SPR4-25-0001, City of La Pine

Planning Memo

October 28, 2025

LA PINE BUSINESS INCUBATOR

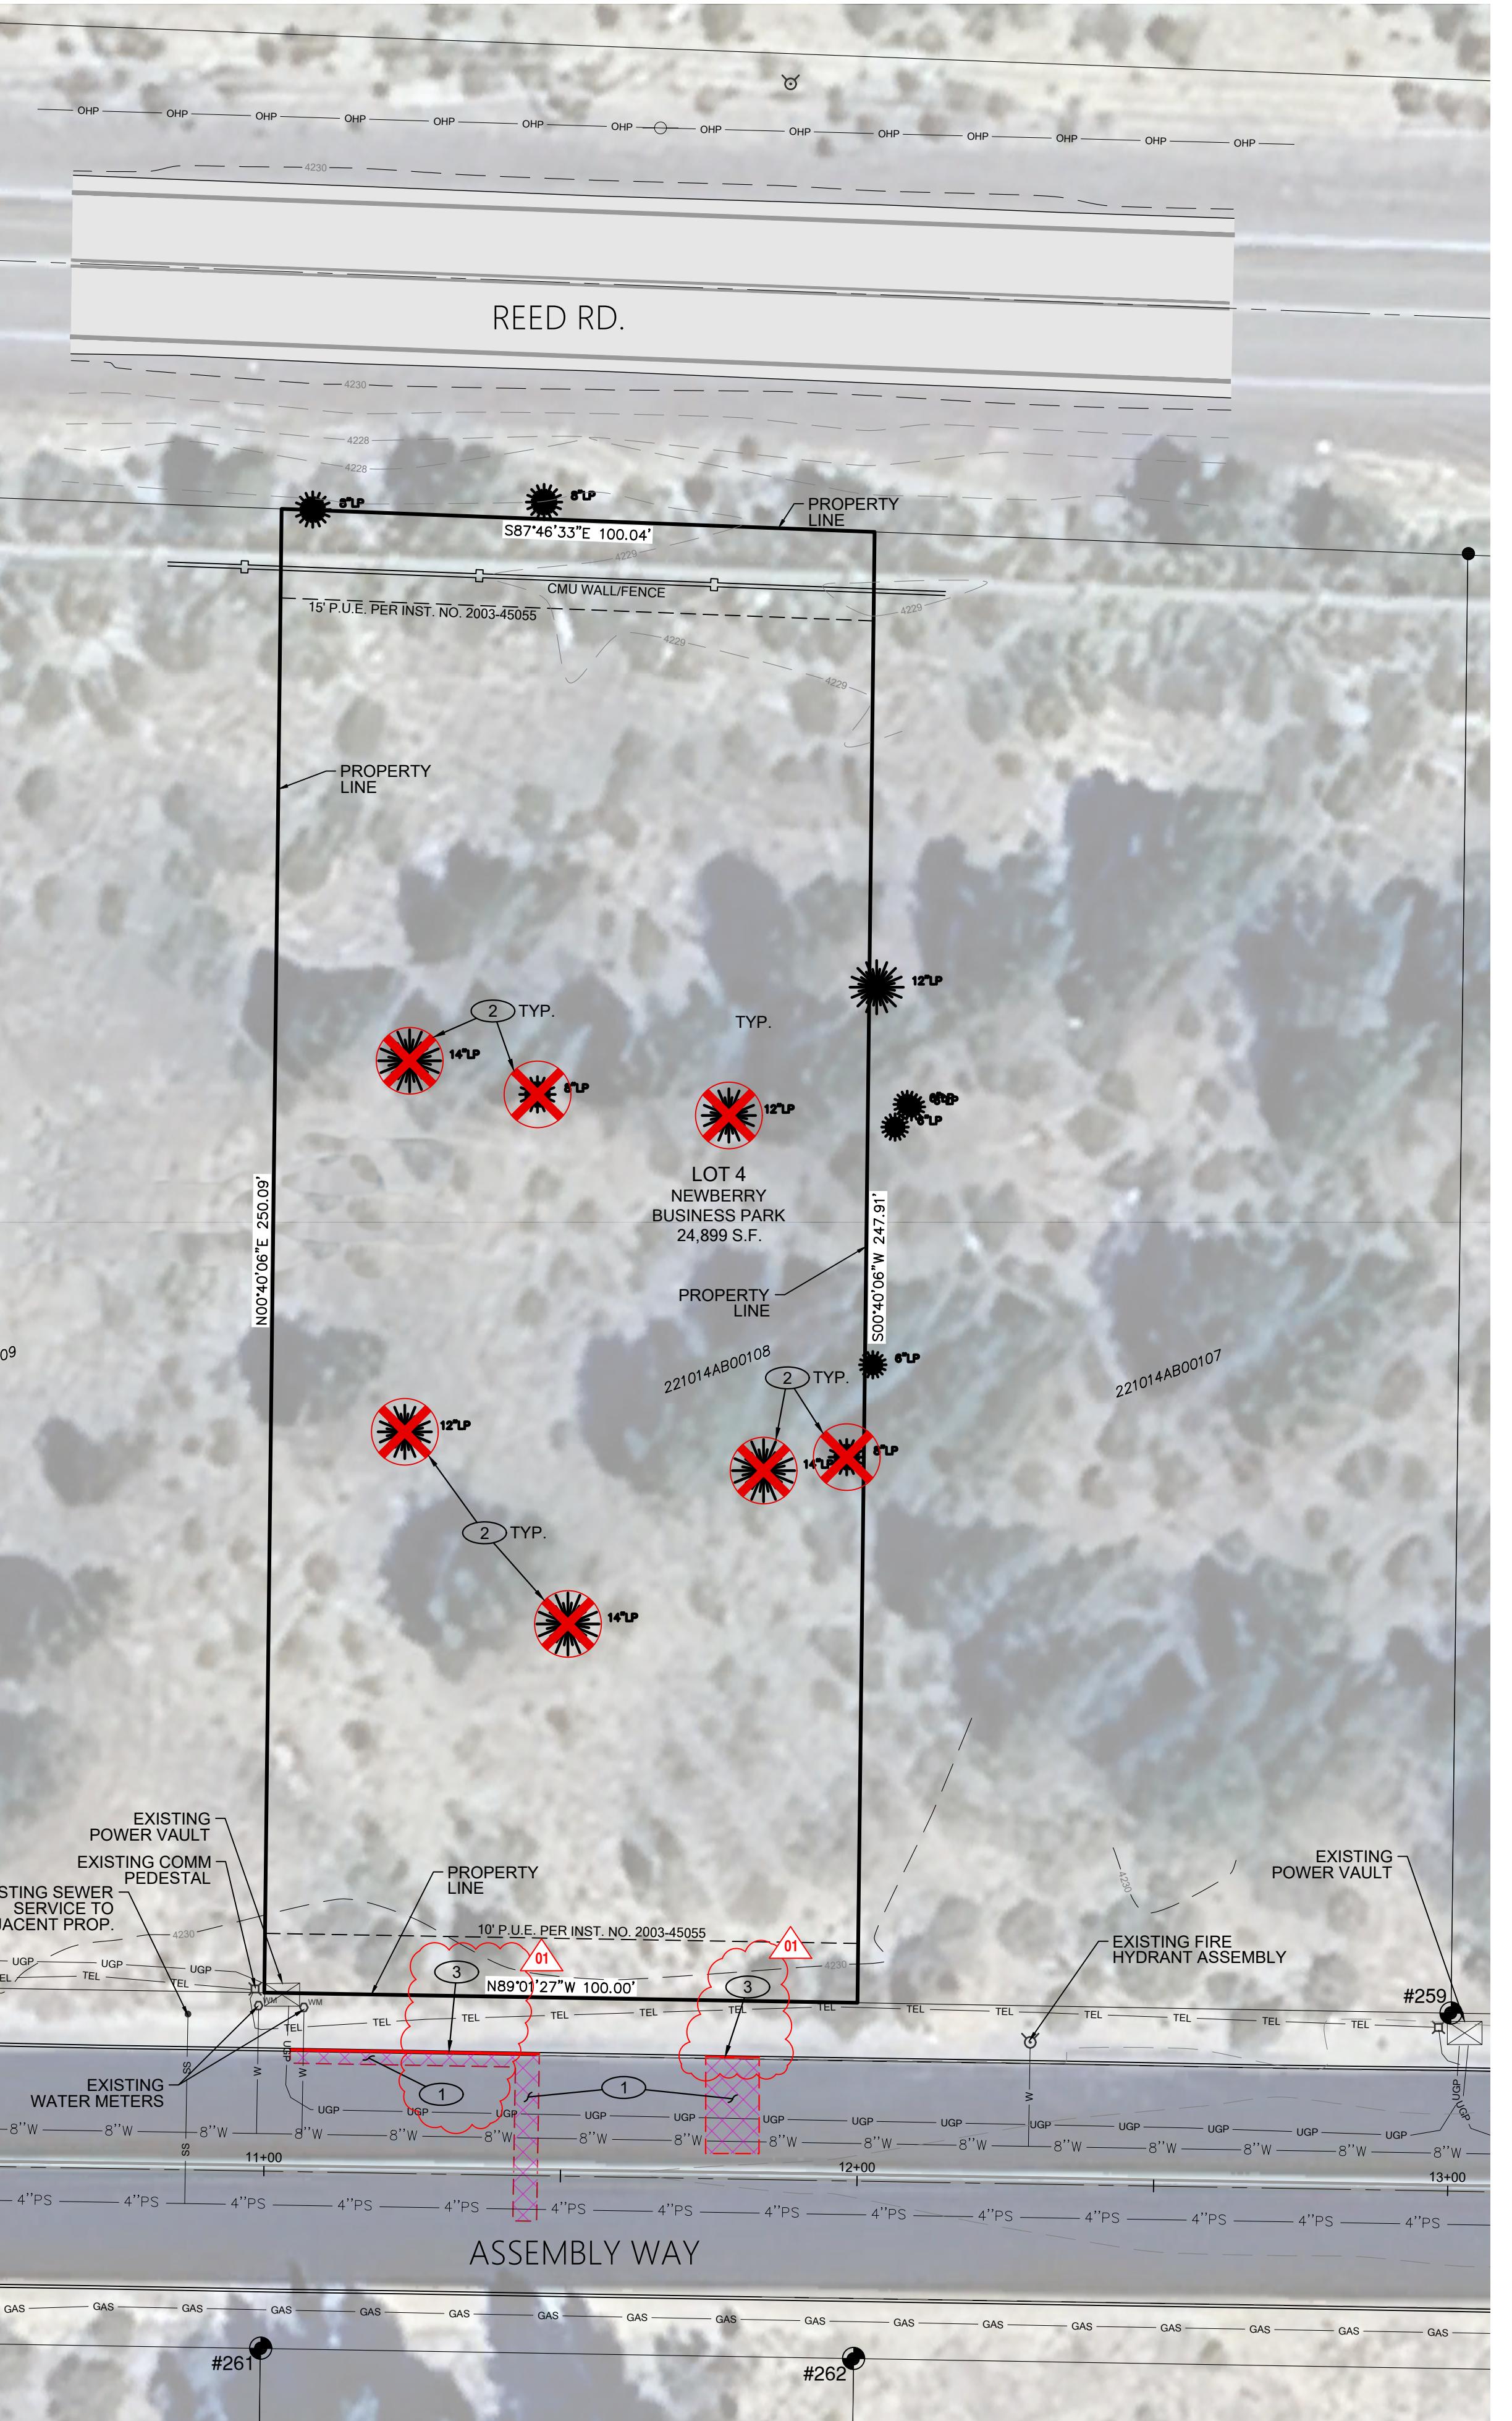
- 4. 15.82.010.I – Please demonstrate compliance with the 1:1 tree replacement standard. It appears that 7 trees are planned for removal but 5 are planned for planting.

Applicant Response: As Noted in the Narrative: *Applicant Response: As detailed on the Plan Set, the site includes 5 trees that are 10" DBH or greater. To accommodate the La Pine Small Business Incubator Facility, all of the trees on the site need to be removed. The 5 trees that are 10" DBH or greater are proposed to be replaced with 5 trees; which conforms to the requirements of this standard.*

UTILITY PLAN

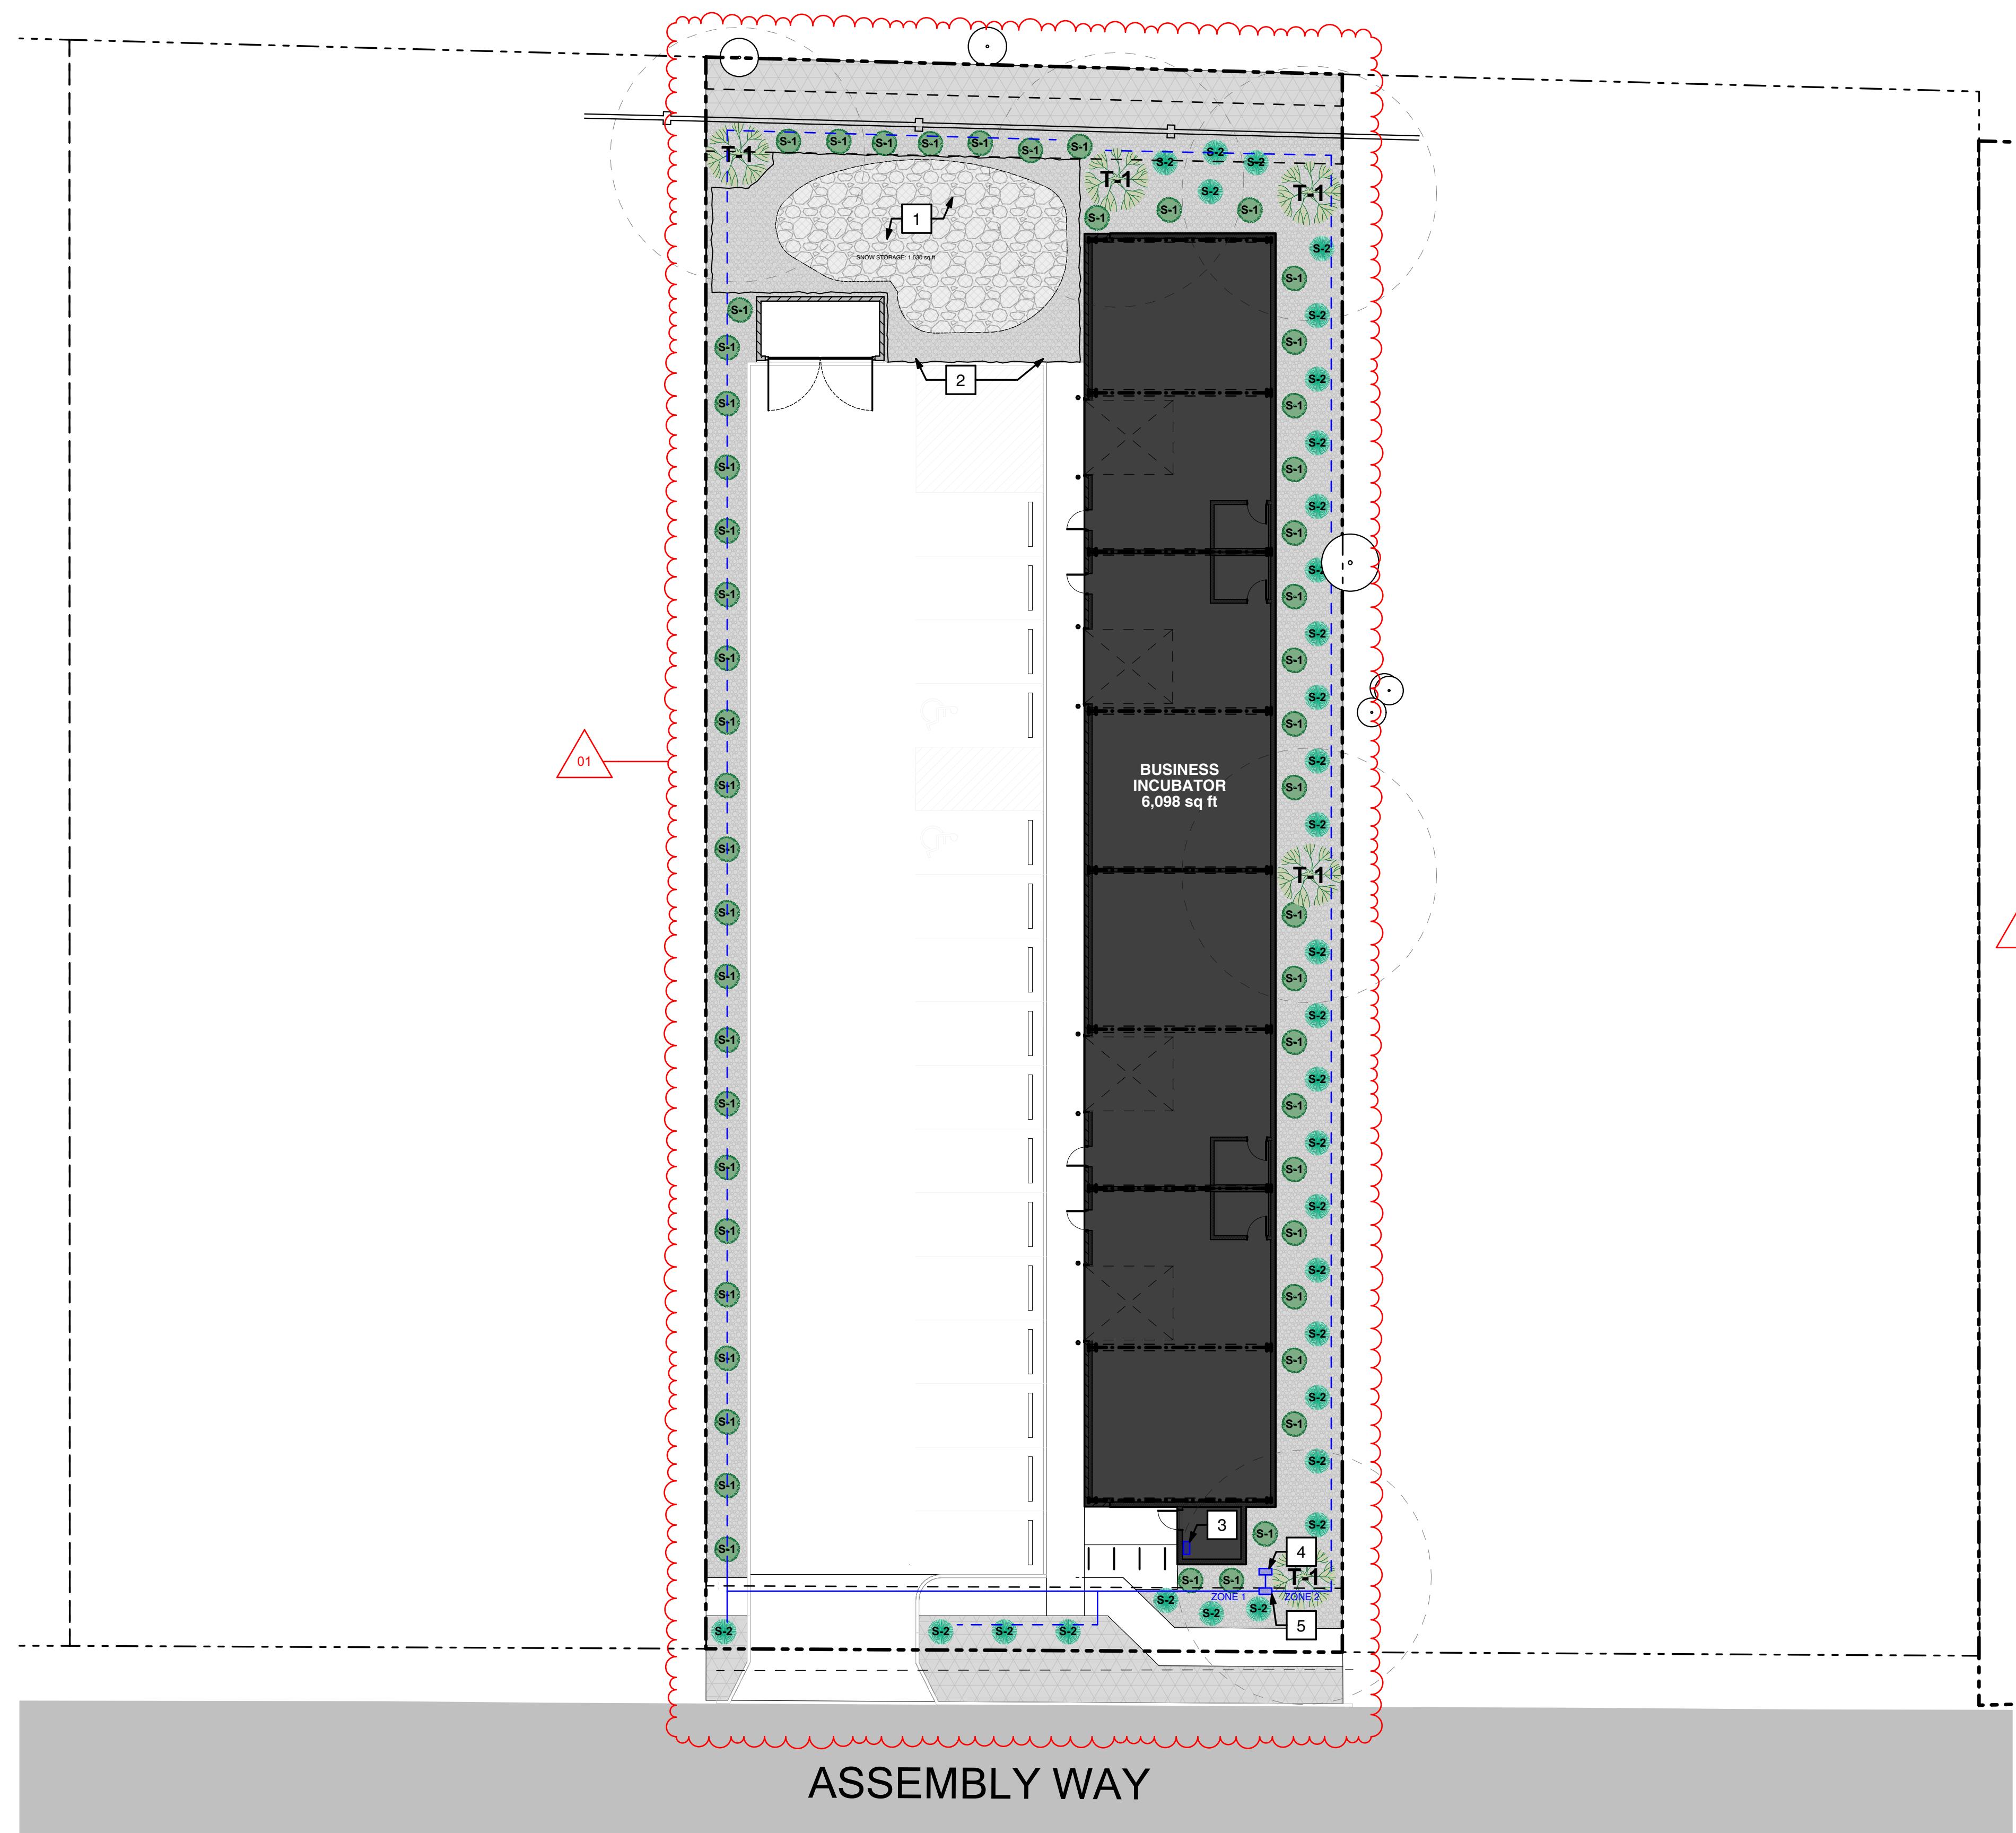
2. *The sidewalk termination setback to the west is much greater than the minimum requirement. This may necessitate the adjacent property owner to adapt their setback to ensure sidewalk continuity. Although this is primarily a City issue, I still wanted to bring it up at this stage.*

Following up on our meeting earlier this week: In conjunction with my comments below [above], per DCC 12.15150(B), sidewalks are required to be property-tight unless otherwise approved by the County Engineer. Given the 6-foot swale constructed as part of the County's UIC replacement project, additional right-of-way will likely be required to accommodate a 6-foot sidewalk along the applicant's frontage.

The sidewalk should be placed on a uniform alignment, property-tight to the new property line. Any deviation from this standard will require specific approval from the County Road Department. Additional discussion with the applicant may be necessary if a deviation is requested

1. Sec. 15.312.060.B.2 says, “In terms of setback from streets or sidewalks, the design creates a visually interesting and compatible relationship between the proposed structures and/or adjacent structures.” Staff are concerned about the off-set design of the walkway and the impacts it may have on future development.
 - a. We're also looking for more understanding: why is the western sidewalk setback so far from the property line, and why is the eastern terminus so close? What's the box on the eastern terminus for?

Applicant Response: The project engineer has indicated “There is an existing transformer vault shown on the utility plan and existing plan that prevents us from connecting at the standard sidewalk setback location”.

Applicant Response: The project engineer has indicated “Sidewalks have been placed with the extents of the Deschutes County's UIC replacement swale in mind.” Also would it be possible that a public easement could be recorded in lieu of additional right-of-way dedication.

Applicant Response: The project engineer has indicated “There is an existing transformer vault shown on the utility plan and existing plan that prevents us from connecting at the standard sidewalk setback location. We request a deviation from the uniform alignment standard to accommodate the existing transformer vault at the west edge of the property.”

Applicant Response: The project engineer has indicated “The originally proposed fire vault near the eastern terminus of the sidewalk has been deleted after clarifying its necessity with Oregon Fire Code. The eastern sidewalk is placed at the proposed back of swale location from Deschutes County’s UIC replacement project.”
